# PCN-20221115 TEI0001-03 to TEI0001-04 Hardware Revision Change

<b>Company</b>	Trenz Electronic GmbH
<b>PCN Number</b>	PCN-20221115
<b>Title</b>	TEI0001-03 to TEI0001-04 Hardware Revision Change
<b>Subject</b>	Hardware Revision Change
<b>Issue Date</b>	2023-01-17

### **#7 Updated components from library.**

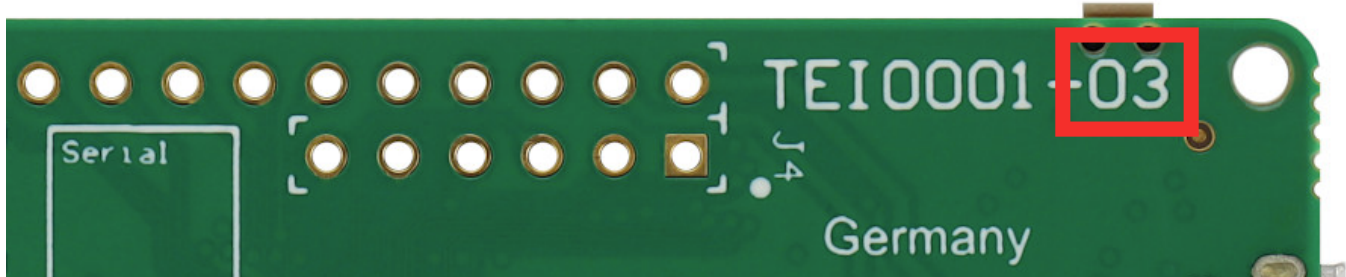
**Type:** Schematic Change

**Reason:** Use latest component data.
